January 26, 1994

Joseph M. Farley Nuclear Plant
Request for Additional Information Regarding
Southern Nuclear Operating Company Responses To
Issues Related to FNP Electrical Distribution System Functional Inspection

Request for Additional Information Regarding Southern Nuclear Operating Company Responses To Issues Related to FNP Electrical Distribution System Functional Inspection

COORDINATION CURVE FOR REACTOR
COOLANT PUMP RELAYS IAC66K & CO-11

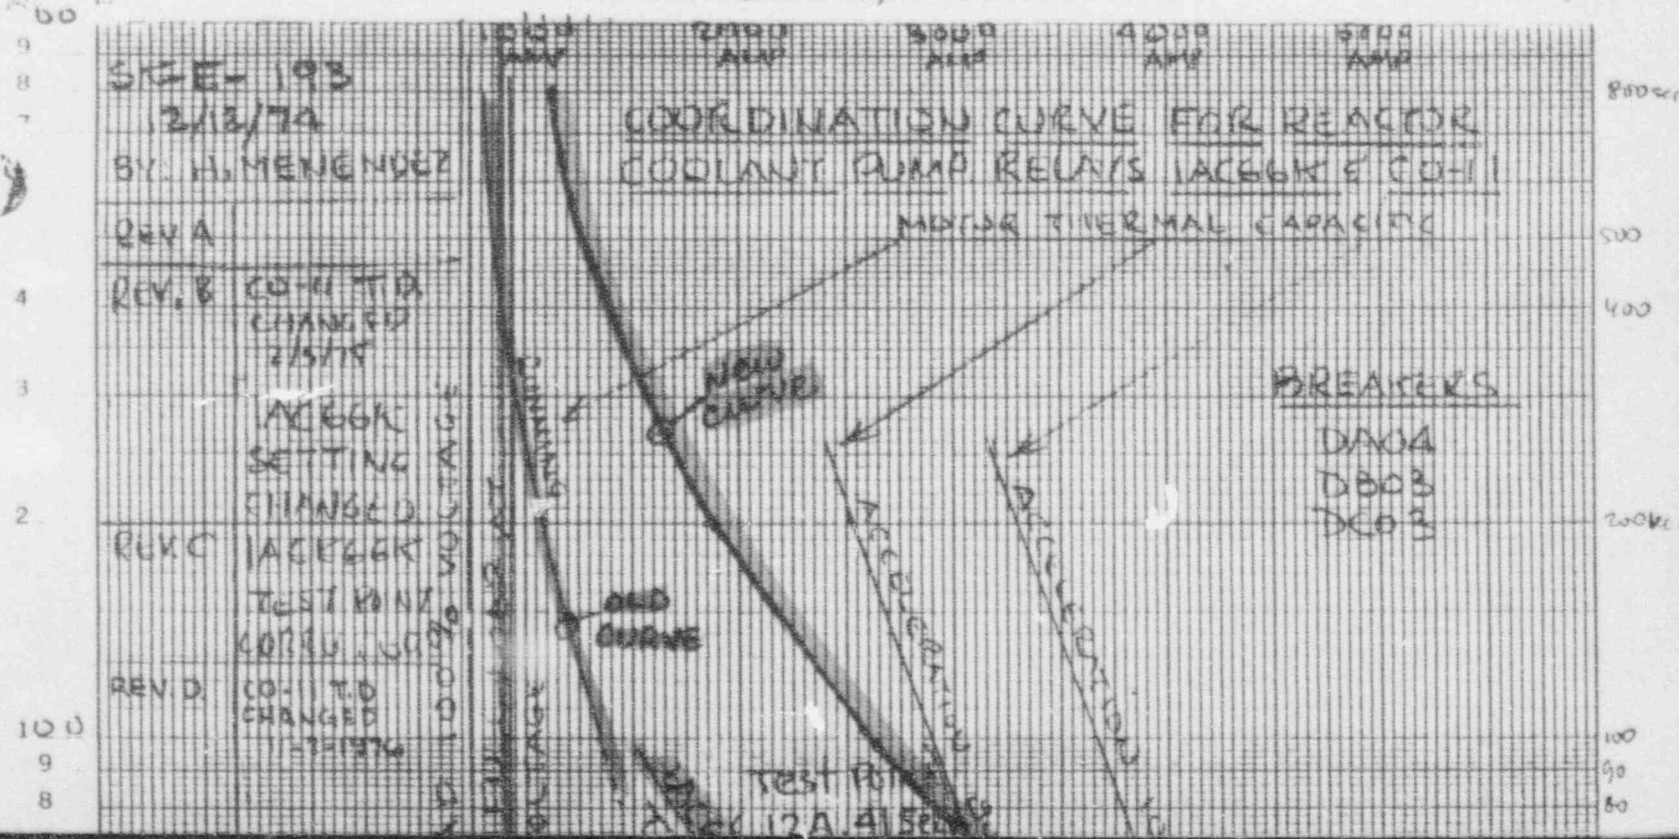
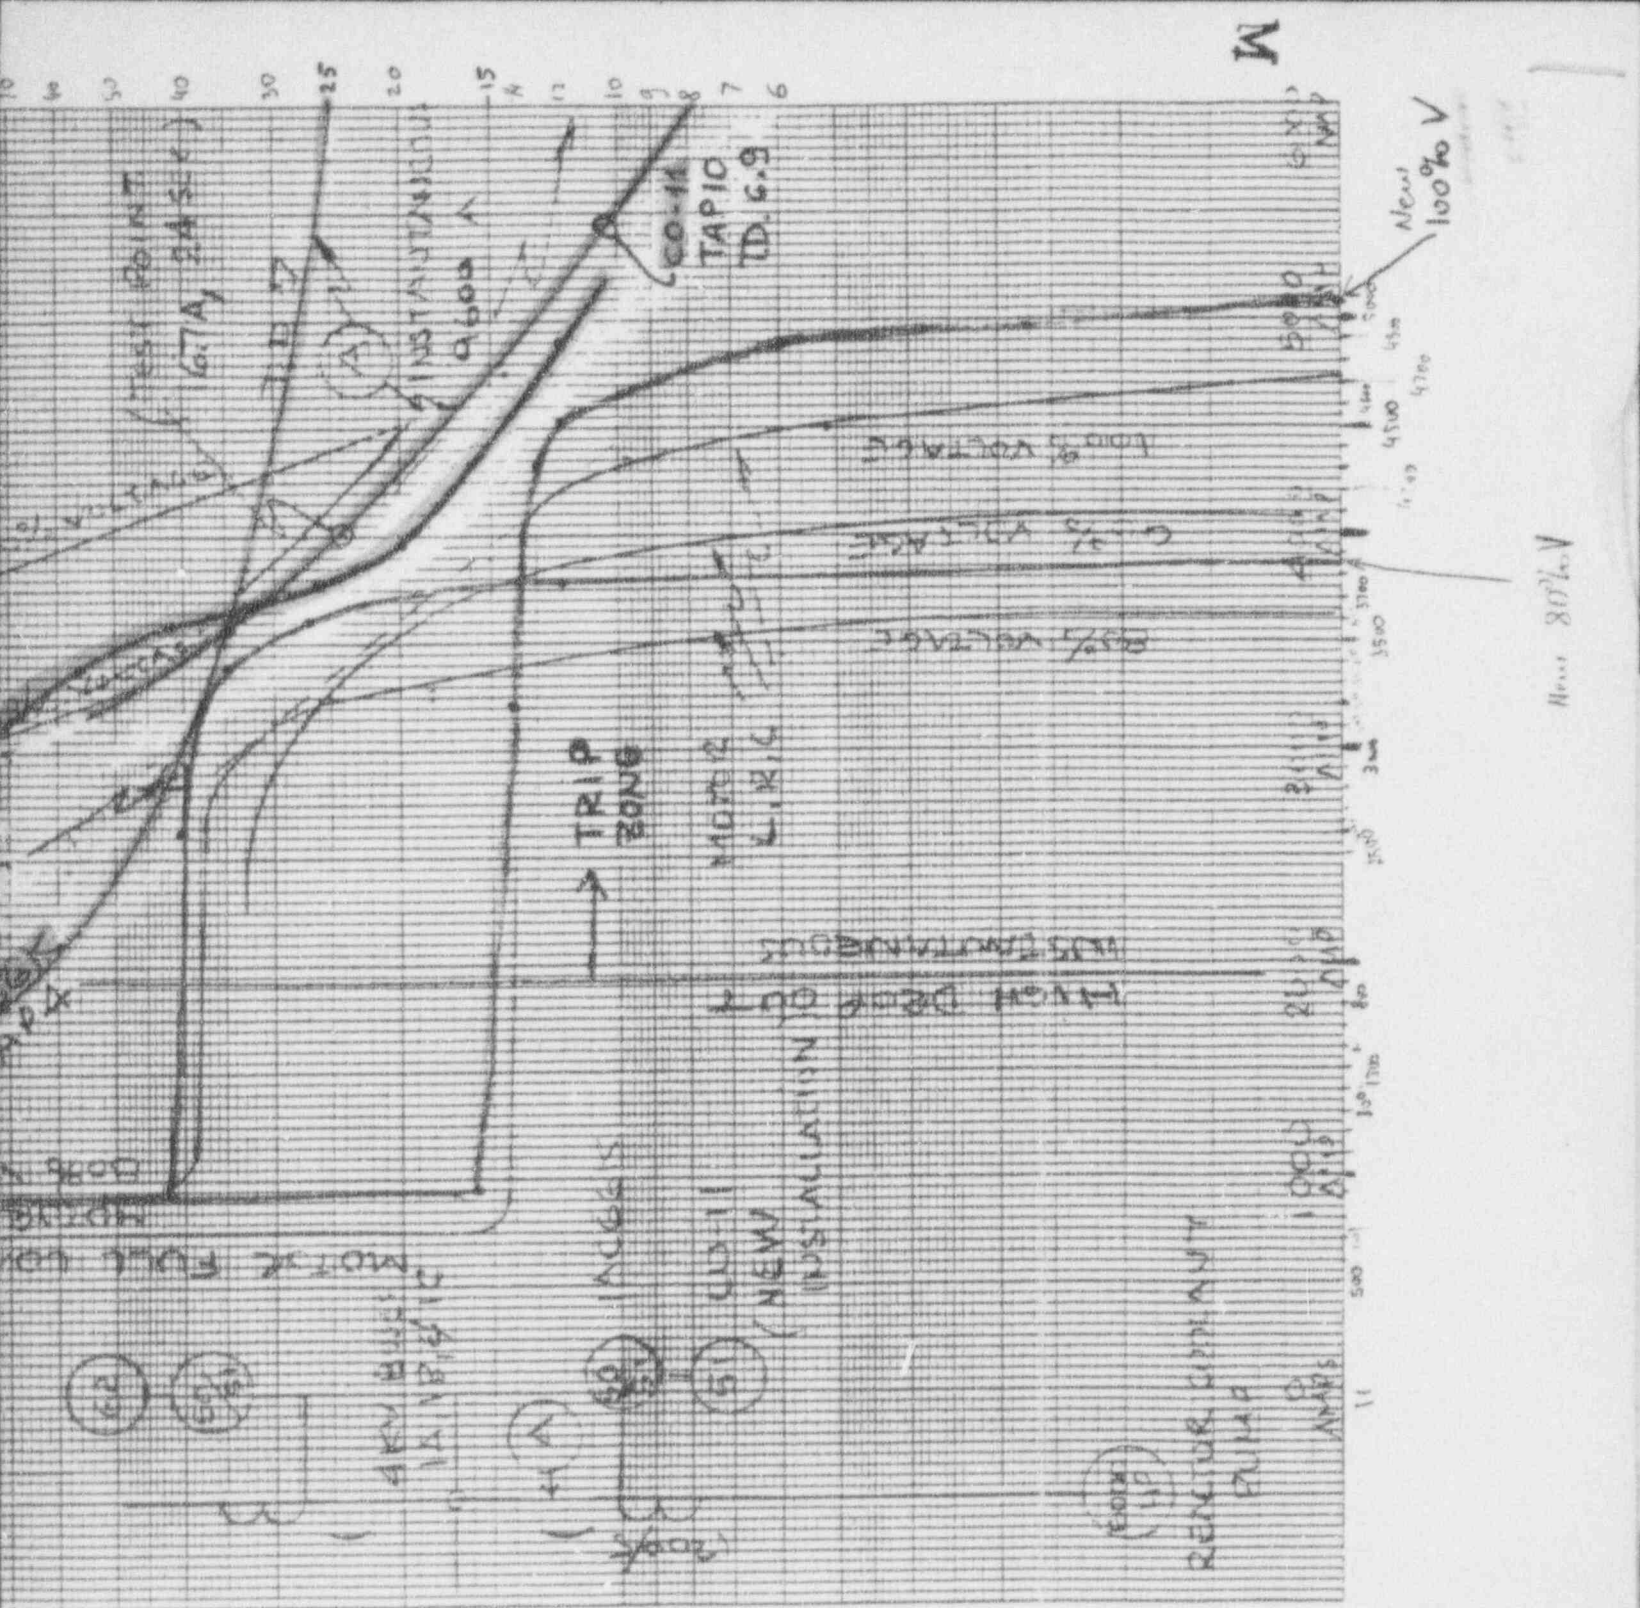
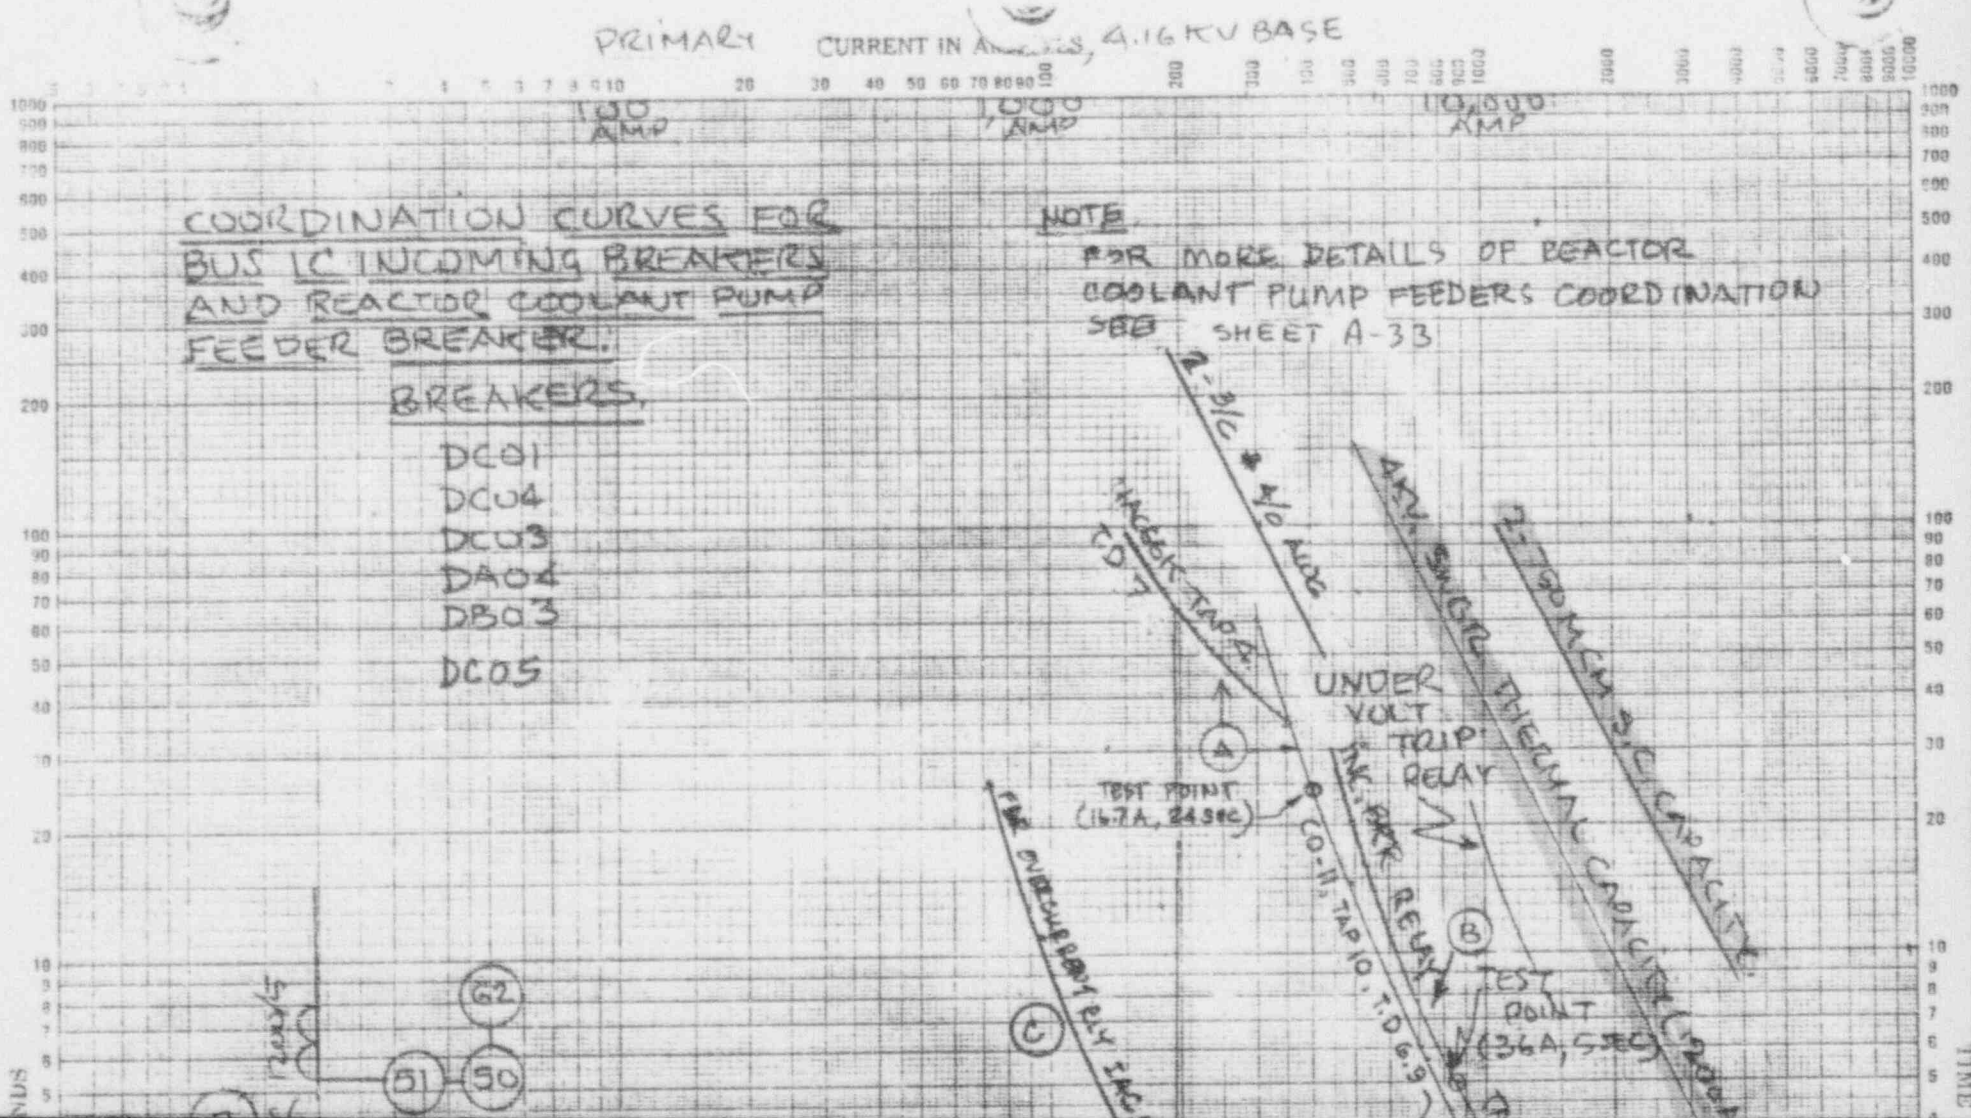
Provide time-current characteristic curves for equipment items associated with the reactor coolant pump motors. The response should include: (1) inrush current (I_s) curves with 80 percent and 100 percent bus voltage available, (2) both relay curves used for the RCP motor protection (IAC66K and CO11), (3) thermal limit curves for RCP motor stator and rotor windings, (4) RCP motor bus upstream main breaker thermal limit curves, (5) RCP motor

cable thermal limit curves, (6) containment penetration thermal limit curves, and (7) fuse thermal limit curves, if fuses are connected in series between the RCP motor feeder breaker and the RCP motor. In addition, provide relay trip setpoints for protective relays IAC66K and CO11.

As discussed in the SNC response to EDSFI issues dated November 5, 1993, the FNP design provides motor winding temperature alarms to ensure protection during motor running (i.e., normal operation below 2000 amps). During motor starting, protection is provided by the combination of IAC66K relay and the CO-11 relay. This combination provides complete protection from approaching the motor thermal limit from 2000 amps to approximately 3700 amps. Above 3700 amps it is possible to exceed the RCP motor thermal limit for a few seconds prior to protective relay actuation. Although this relaying scheme does not afford complete protection from exceeding the thermal limit, this scheme was determined to be optimal, in terms of maximizing motor protection while limiting nuisance trips, during plant design and startup. Experience has confirmed these settings to be adequate.
